Agenda Item # 1 - HOLDOVER

SUB-003093-2024 & MOD-003094-2024

Christ United Methodist Church West Subdivision

- Subdivision approval to create three (3) legal lots of record
- Modification of a previously approved Planned Unit Development

SITE PLAN

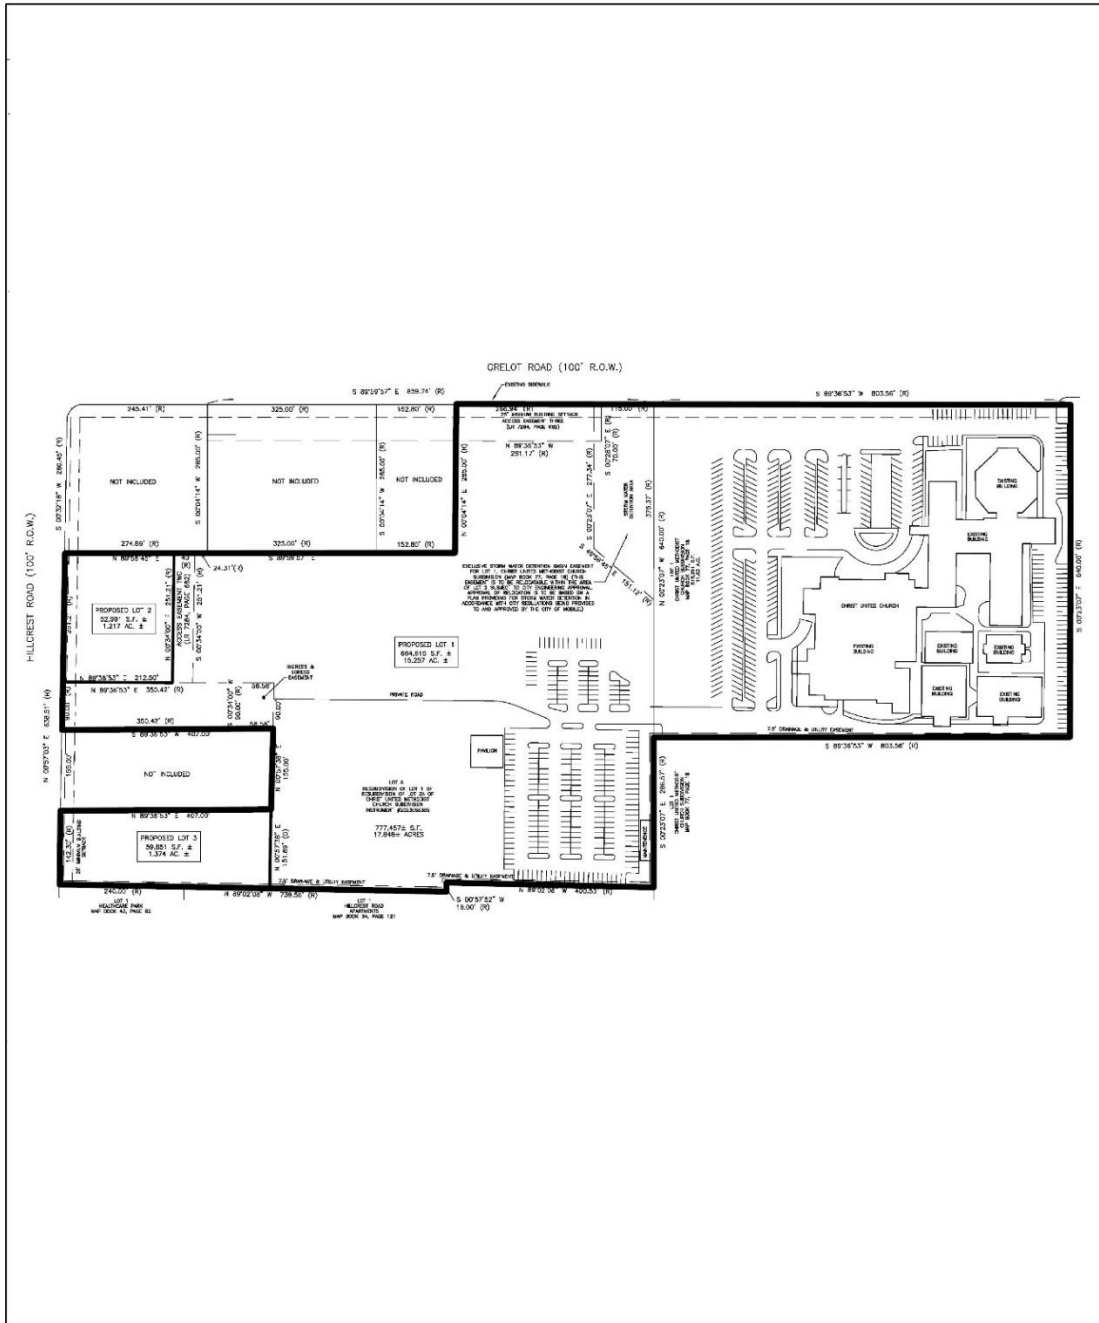
The applicant has submitted a revised site plan depicting the entirety of the PUD, as required.

It should also be noted that the applicant is requesting to remove proposed Lots 2 and 3 from the Planned Unit Development (PUD). PUD approvals are site plan specific, and approvals may contain specific conditions regarding site access, site design and site buffering – all of which may differ from the standard requirements of the Zoning Ordinance and Subdivision Regulations. Therefore, removal of a property from a PUD may require that specific conditions from the PUD be placed on the property being removed from the PUD. Furthermore, changes to the PUD may trigger additional conditions due to the alteration of various development factors, such as property access. For this site, the proposed removal of Lots 2 and 3 from the PUD - where it was assumed that these properties would access private internal drives - would then limit these properties to access only to and from Hillcrest Road, which would then potentially necessitate additional review by and conditions from Engineering and Traffic Engineering and possible amendment of recorded subdivision plats and new zoning conditions.

All three (3) lots, as proposed, will exceed the minimum size requirements for lots served by public water and sanitary sewer in a B-3, Community Business Suburban District. Each lot is labeled with its size in both square feet and acres on the preliminary plat, and this information should be retained on the Final Plat, if approved; or the provision of a table on the Final Plat with the same information will suffice.

The required 25-foot minimum front yard setback is illustrated along both Grelot Road and Hillcrest Road, and should be retained on the Final Plat, if approved.

The preliminary plat depicts several existing easements: three (3) access easements, a stormwater detention basin easement, and a drainage and utility easement. These easements should be retained on the Final Plat, if

approved, as well as the note stating that no structures are allowed to be erected in any easement, without the easement holder's permission.
